DATE	REVISION
7/30/21	90% CITY REVIEW
3/19/22	100% PERMITTING SUBMITTAL
7/11/22	ADDENDUM NO 2 GDOT ENTRANCE

FLOWERY BRANCH WRF EXPANSION
 CITY OF FLOWERY BRANCH, GA
 GA D.O.T. ENTRANCE
 SITE PLAN AND STAKING

FLOWERY BRANCH WRF EXPANSION
CITY OF FLOWERY BRANCH, GA
GA D.O.T. ENTRANCE
GRADING AND DRAINAGE

FLOWERY BRANCH WRF
UPGRADE TO 2.2 MGD

GA D.O.T. ENTRANCE- SITE PLAN
 1"=20'

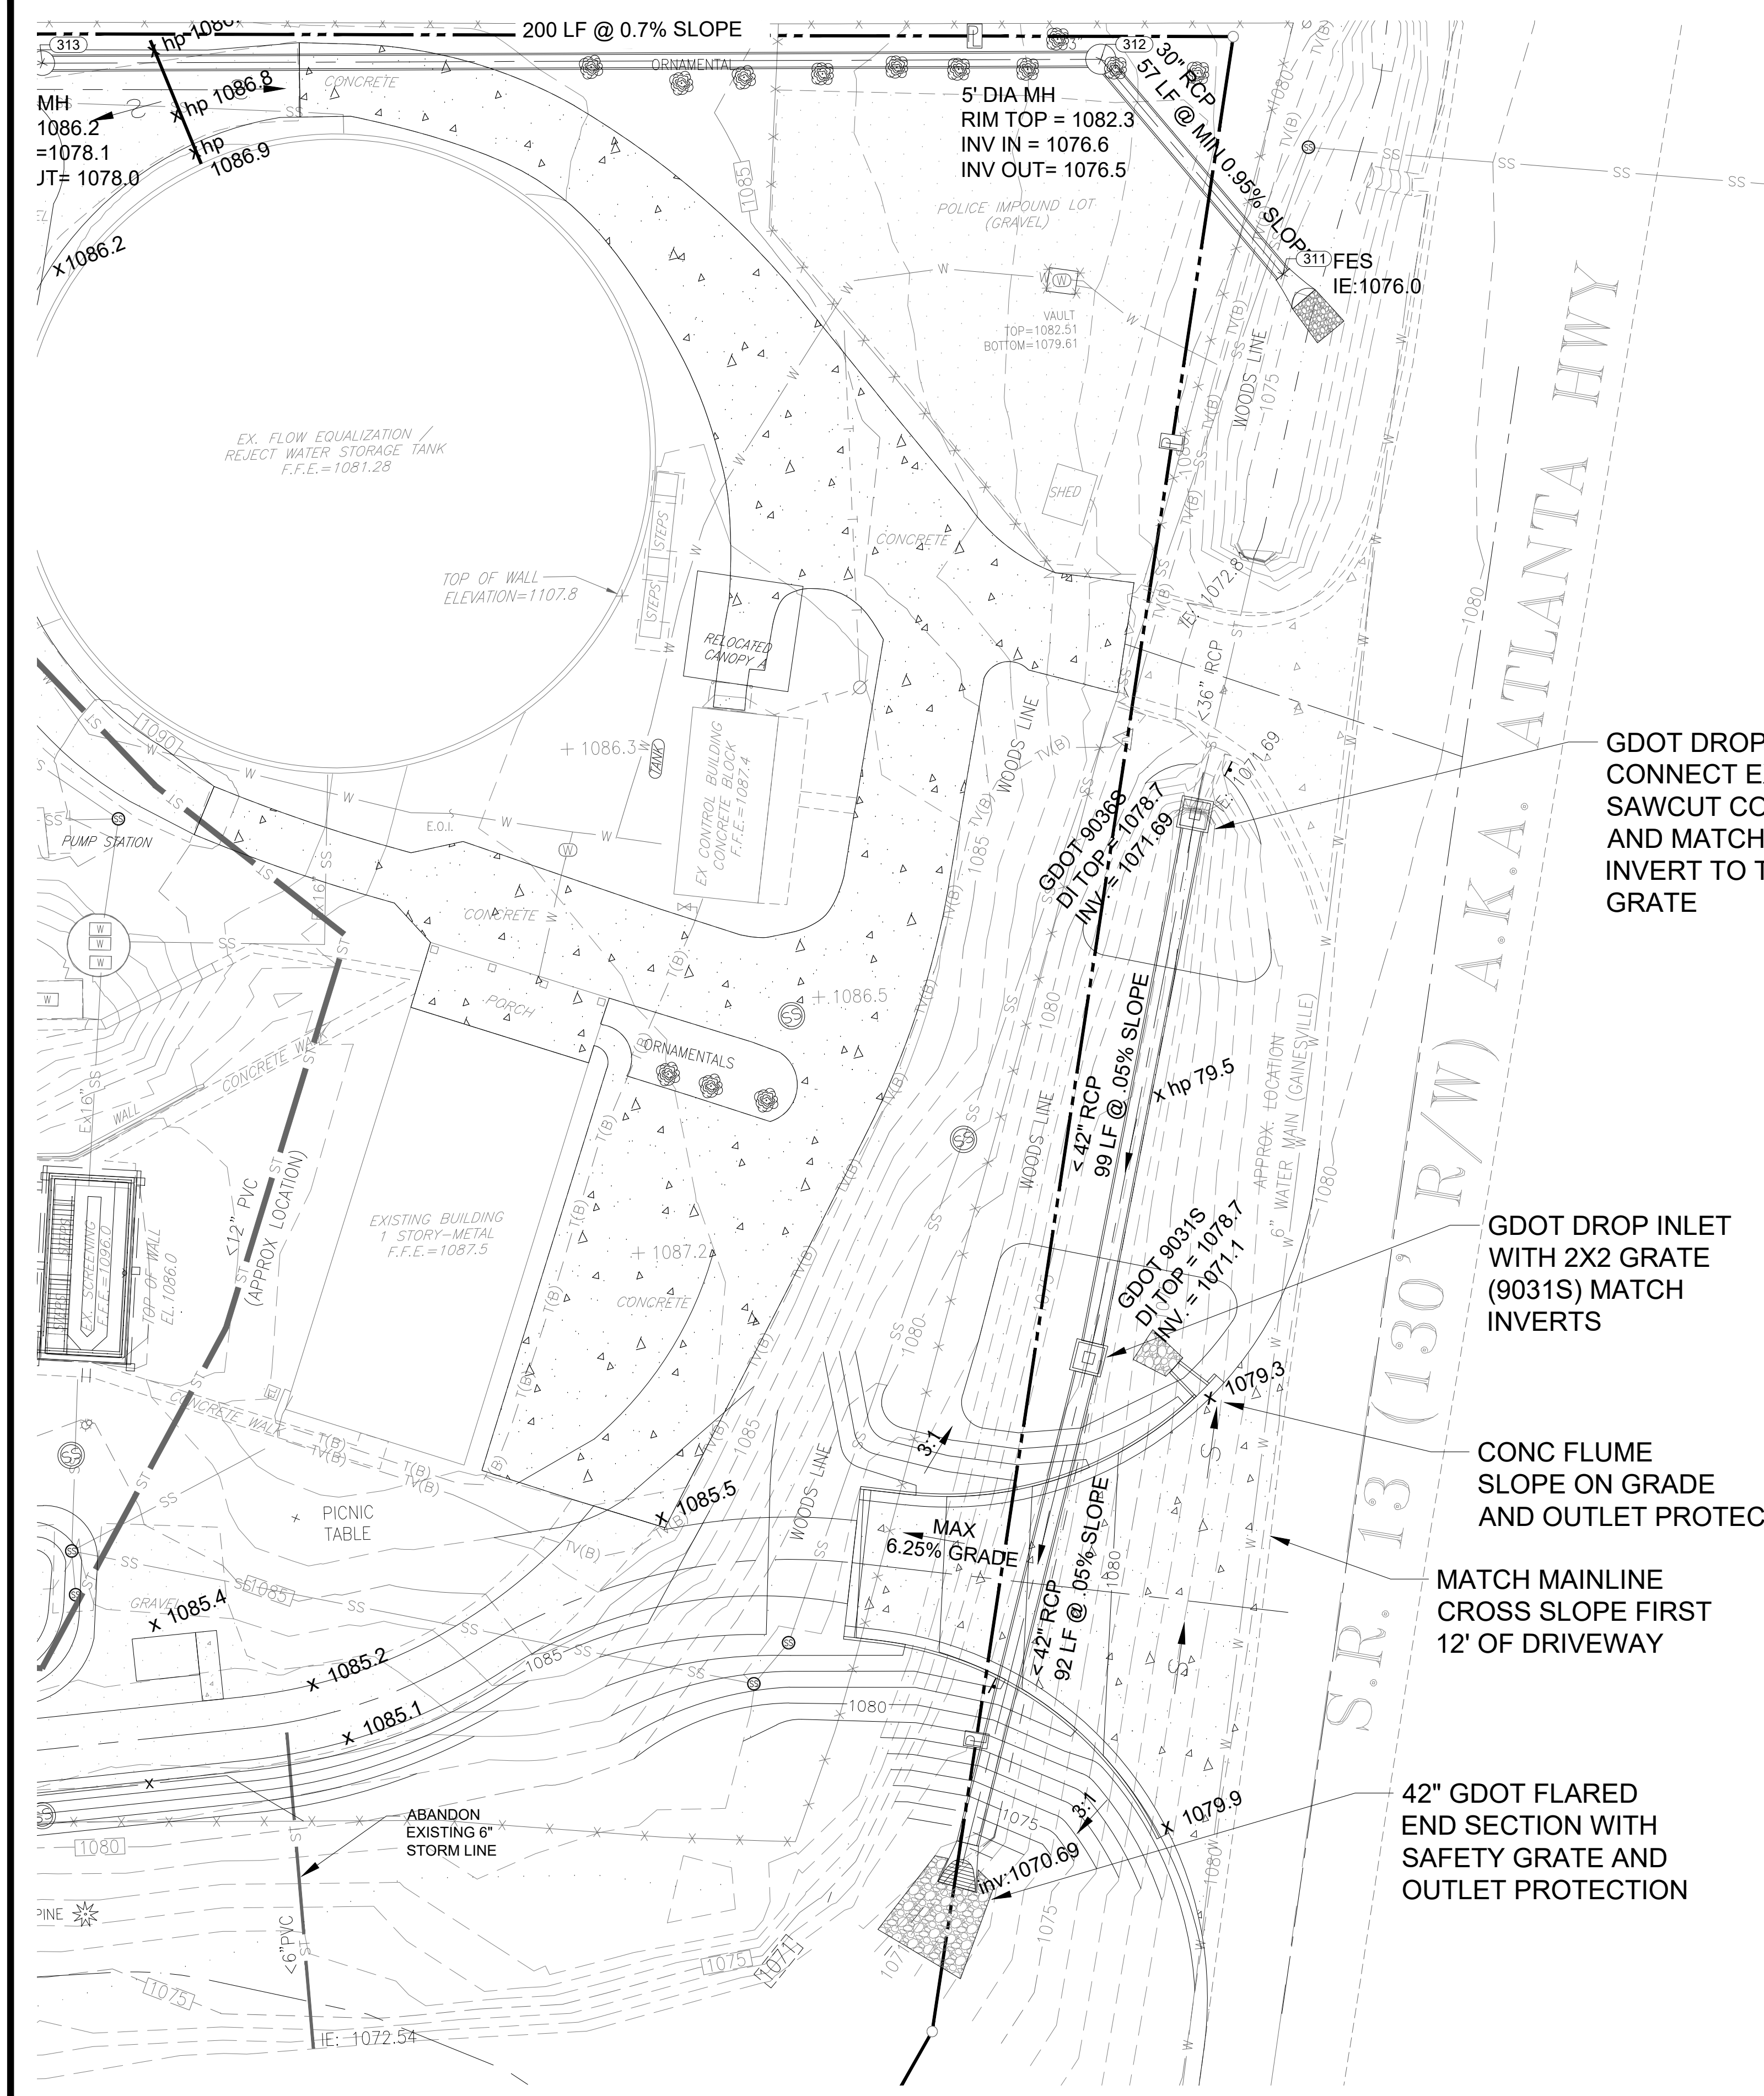
GDOT DROP INLET
CONNECT EX 36" RCP
SAWCUT CONC. FLUME
AND MATCH FLUME
INVERT TO TOP OF
GRATE

GDOT DROP INLET
WITH 2X2 GRATE
(9031S) MATCH
INVERTS

CONC FLUME
SLOPE ON GRADE
AND OUTLET PROTECTION

MATCH MAINLINE
CROSS SLOPE FIRST
12' OF DRIVEWAY

42" GDOT FLARED
END SECTION WITH
SAFETY GRATE AND
OUTLET PROTECTION

ENLARGED DEMOLITION PLAN EAST

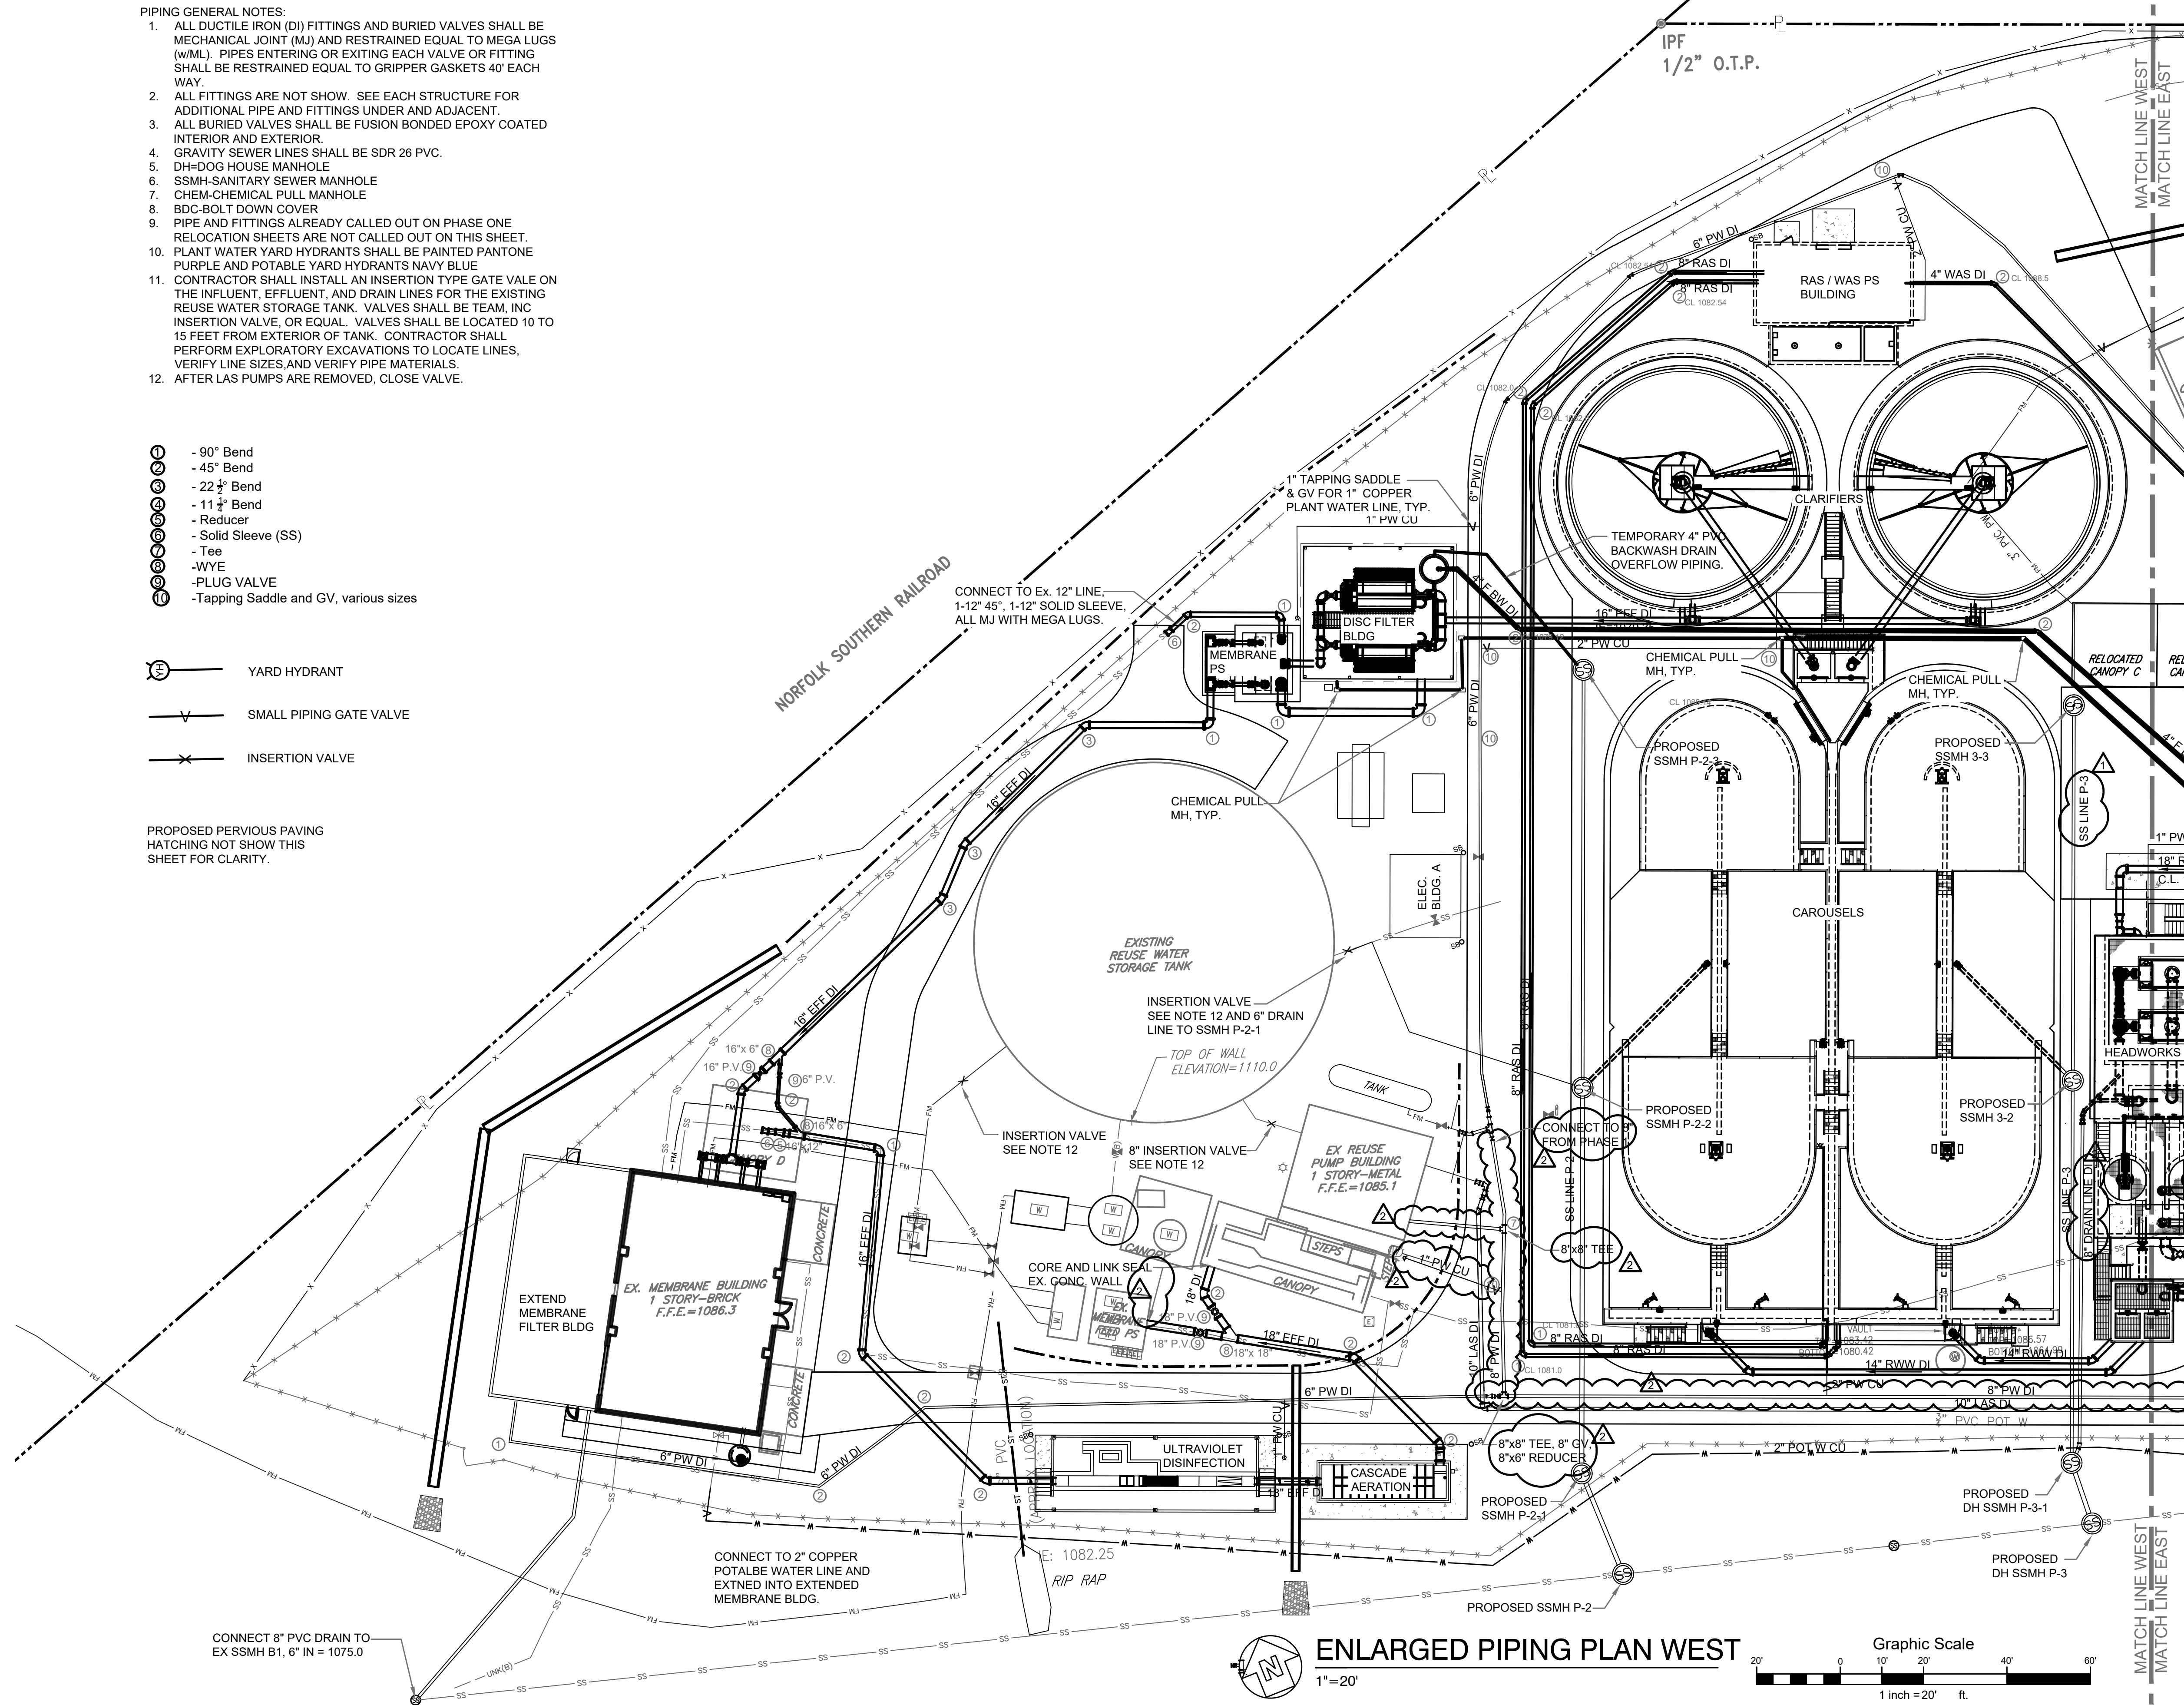
PROPOSED RELOCATED 10" DIP SPRAY FIELD FORCE MAIN IN INITIAL PHASE AND WILL BECOME PART OF THE PLANT WATER SYSTEM.

ELECTRICAL DUCTBANK RELOCATION SEE ELECTRICAL DRAWINGS FOR ADDITIONAL DETAILS

RELOCATE FILTER AND APPURTENANCES, REMOVE STRUCTURES AFTER RELOCATED

CORE & BOOT EX. MH, RE-ROUTE FLOW, PLUG 8" LINE TO EX. SSMH D2

EXISTING 4" NON-REINFORCED CONCRETE DRIVES AND PARKING SHALL BE REPLACED WITH 8" REINFORCED CONCRETE OVER 8" GAB IN SAME LOCATIONS AND GRADES.

CORE & BOOT EX. MH, RE-ROUTE FLOW, PLUG 8" LINE TO PUMP STATION

CORE EX. MH B4 FOR NEW 18" SDR PVC AND PLUG EX 15" PVC AND 8" DIP LINE. 18" INV. IN=1065.75

EXISTING 4" NON-REINFORCED CONCRETE DRIVES AND PARKING SHALL BE REPLACED WITH 8" REINFORCED CONCRETE OVER 8" GAB IN SAME LOCATIONS AND GRADES.

CONNECT TO EXISTING 10" DIP SPRAY FIELD FORCE MAIN IN INITIAL PHASE, SEE NOTE 13. 10" SOLID SLEEVE 10" 11" BEND, 10" PV MJ FITTING WITH MEGA LUGS.

ABANDON 6" DIAMETER PREVIOUSLY CONVERTED LIFT STATION TO MH B3, REMOVE TOP AND SIDE TO 10' BELOW GRADE, FILL REMAINING WITH CONCRETE FILL.
